University Avenue Overcrossing Vertical Clearance Project

DISTRICT 4 – ALA – 80 (PM 5.8/5.8)

Initial Study with Negative Declaration

State of California Department of Transportation

Figure 2.1.7-3: Projected Sea Level Rise: Represents 2 feet of Sea Level Rise (year 2050)

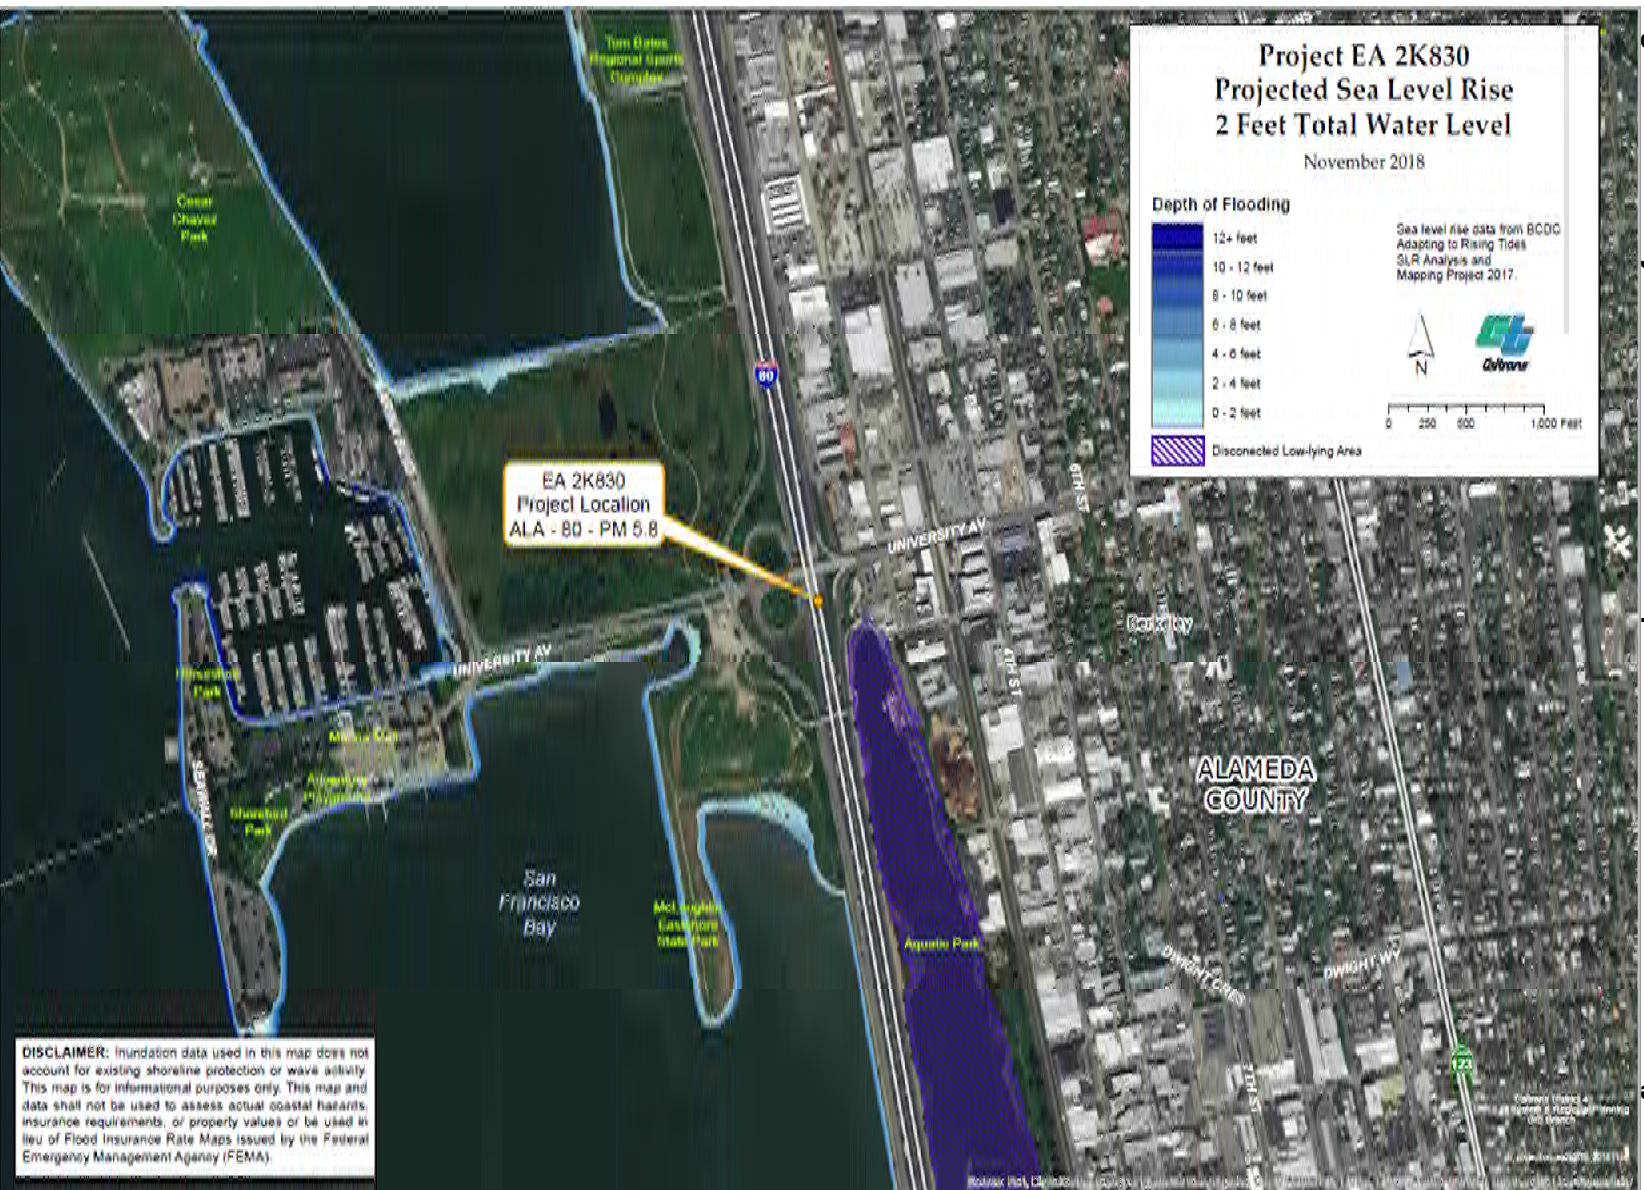
The project will not change the existing land-use pattern at the project site and will not create additional flooding hazards. Caltrans does not anticipate any impacts from the project involving wave action, coastal hazards, tsunamis, mudflow, or Sea Level Rise (SLR). Please refer to Figure 2.1.7-3, which depicts SLR projected to year 2050. The project falls outside of the SLR impact area. Therefore, no mitigation is required.

Please refer to Figure 2.1.7-3, which depicts SLR projected to year 2050. As you can see, the project falls outside of the SLR impact area.
